UPDATED: Feb 7, 2020

This document presents the Questions asked by Ontario Teams and the Answers provided (Bob Tone).

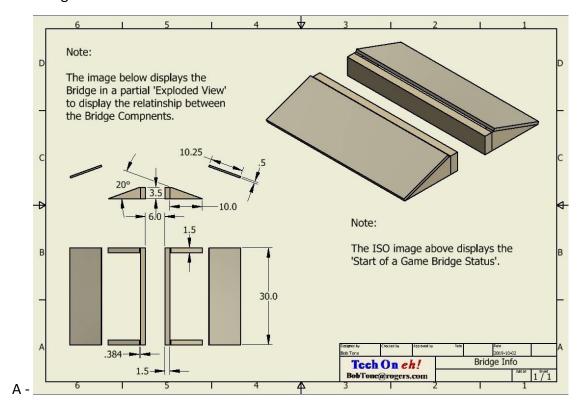
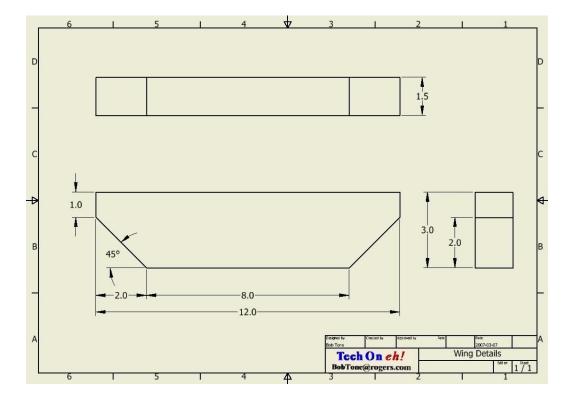
Q - Any assembly drawings of the bridge available? Also, do you have the specific dimensions of the wing.

Q - On Page 2 of the "2020 Skills Ontario Robotics Questions and Answers" document, our class has a question regarding the bridge assembly.

On the side view, the top of the bridge appears to be flush. However, on the isometric view, there's a small lip on the ramp side.

Our class was wondering which one of the drawings we should follow.

A - The Bridge Plates are not intended to be a tight fit when they are put in place.

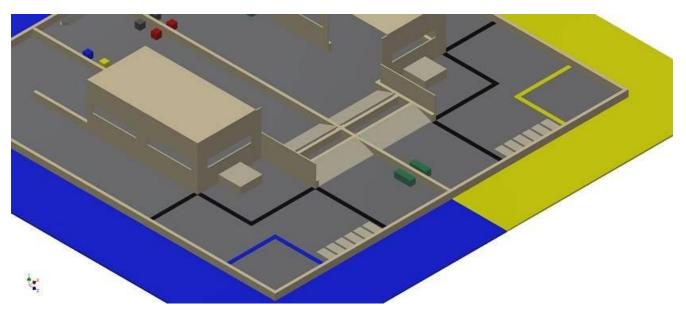
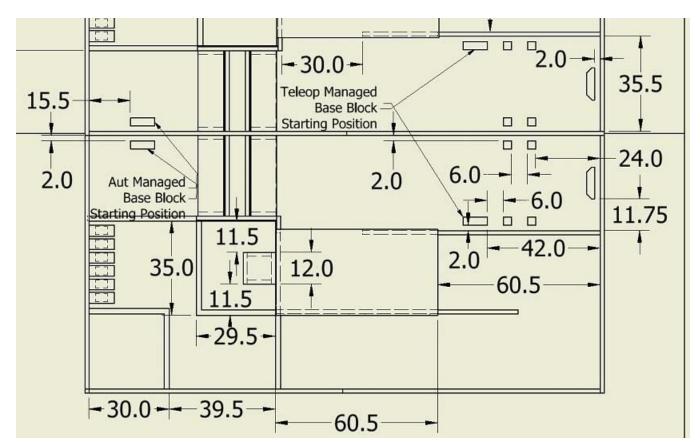
I have participated in a discussion with the National Technical Committee regarding the question of placement of the Base Block and the images below are being provided to clarify the matter.

The Base Block will be placed 2 inches away from the center wall in the same manner as all of the Totem Pole Blocks.

"I have made all the pieces out of foam and duct tape. They are very very light even with the tape.

Base Block = 54 grams

Totem Pole Cube Blocks = 18 grams

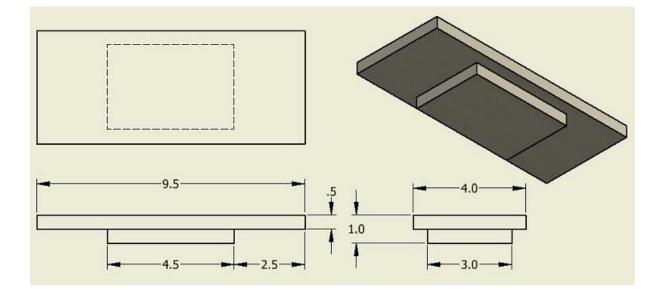
Q - Are we allowed to cross the bridge before it's completed?

A - There is no restriction stated in the scope regarding when a robot can cross over the bridge.

Robots can cross over the bridge whenever their robot's performance capabilities will support success.

- 6 Bridge Plates in position,
- 5 Bridge Plates in position,
- 4 Bridge Plates in position,
- 3 Bridge Plates in position,
- 2 Bridge Plates in position,
- 1 Bridge Plate in position, or,
- 0 Bridge Plates in position.

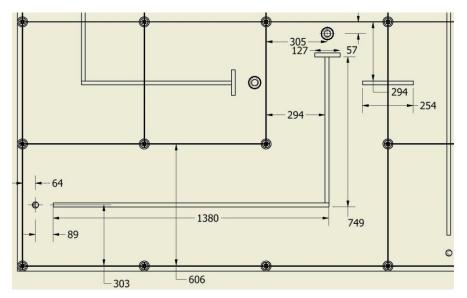
Due to the kindness of Luca at Michael Power / Saint Joseph's Catholic High School 48 Bridge Plates have been made and offered for use at the Skills Ontario Competition.

He used 1/2" plywood, Good One Side with the finished side on the top and at the bottom. Glued the top and bottom piece with wood glue and clamped it. They are extremely strong.

There will be no screws in the competition Bridge Plates.

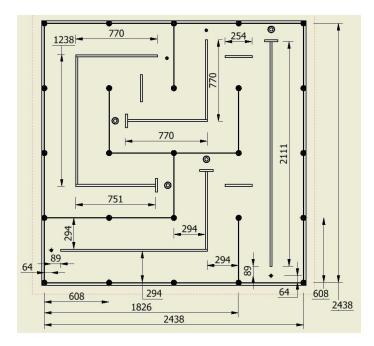
Q - I was wondering if there is any chance that we might get a full schematic with measurements for the autonomous field?

A - I expect the image below provides adequate measurement details to enable competitors to prepare for the Autonomous Golf Game.

Keep in mind that these measurements are based on an Inventor Model.

It is expected competitors will base their final competition files on actual measurements they have retrieved for themselves from the specific court to which they have been assigned.

It is impossible to guarantee the final court measurements will be 'Correct to the millimeter' when compared with the values displayed below.

NOTE: The scope references the robots at the start of a game must be ON the fairway tape line and have the ball OUT f reach by their object management system. To be consistent we will require the robot to be behind the first set of court wall posts (608 mm away from the wall behind the tee).

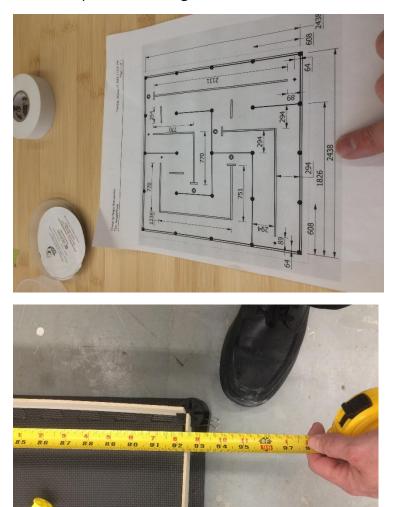
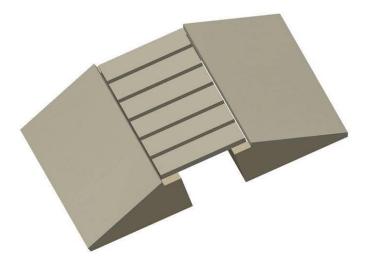
Q - We're having an issue with the given field measurements (autonomous) w.r.t. the kit field measurements.

From this picture, the edge measurement converted to imperial is 8 ft.

The distance between walls is supposed to be 24 in. from what we can see in the diagram. We're measuring 23 in. between walls (our tape is .75 in. wide from the kit not sure what it is in the diagram).

A - I did not / do not have an actual court kit.

I created the drawings based on what I understood were the court details.

The expectation is teams will create control files at their school before coming to the competition using the provided in the document details.

Retrieving the actual measurements from the competition courts and making the necessary adjustments to their control files is an expected competitor performance requirement.
